Access Compliance Report

Public Rights-of-Way

(Curb Ramps)

Intersection ID: 47915	Main Street: ROOK_RD	Cross Street: OAKDALE_RD	Location:	N
ADA ID: 73C7565B06DD	Ramp Type: Perp	Initial Pass/Fail: Fail	Overall Compliance: No	Severity Score: 12.5
Codes/Mitigation Info/Possible Solution		Field Measurements/Component Compliance

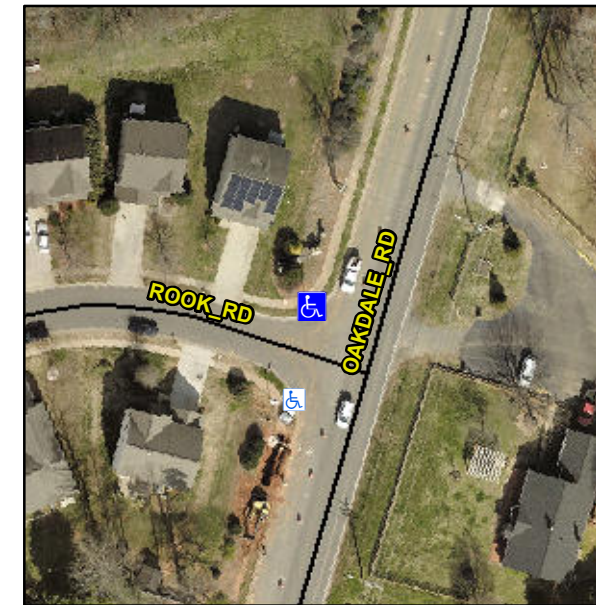
Not Found, R304.2.2

Compliance	Description	Data	Compliance	Description	Data
N/A	Ramp Length (in)	49.0	No	Ramp Slope (%)	11.2
Yes	Ramp Width (in)	48.0	Yes	Ramp XSlope (%)	1.3
N/A	Flare Type LT	N/A	N/A	Flare Type RT	N/A
N/A	Flare Slope LT (%)	N/A	N/A	Flare Slope RT (%)	N/A
N/A	Flare Traversable LT?	N/A	N/A	Flare Traversable RT?	N/A
N/A	Landing Length (in)	N/A	N/A	DWS Provided?	N/A
N/A	Landing Width (in)	N/A	N/A	DWS Contrast?	N/A
N/A	Landing Slope (%)	N/A	N/A	DWS Length (in)	N/A
N/A	Landing X Slope (%)	N/A	N/A	DWS Full Width?	N/A
N/A	Landing Curb? (Y/N)	N/A	N/A	DWS Offset (in)	N/A
N/A	Shared Landing?	N/A			
N/A	Gutter Ponding?	N/A	N/A	Gutter Slope (%)	N/A
N/A	Gutter Lip Ht (in)	N/A	N/A	Gutter X Slope (%)	N/A
N/A	Painted X Walk1?	No	N/A	Painted X Walk2?	N/A
	X Walk 1 Direction	To SW		X Walk 2 Direction	N/A
N/A	X Walk 1 Width (in)	N/A	N/A	X Walk 2 Width (in)	N/A
	X Walk 1 Slope (%)	3.8		X Walk 2 Slope (%)	N/A
	X Walk 1 X Slope (%)	2.1		X Walk 2 X Slope (%)	N/A

Remove & Replace Entire Ramp.
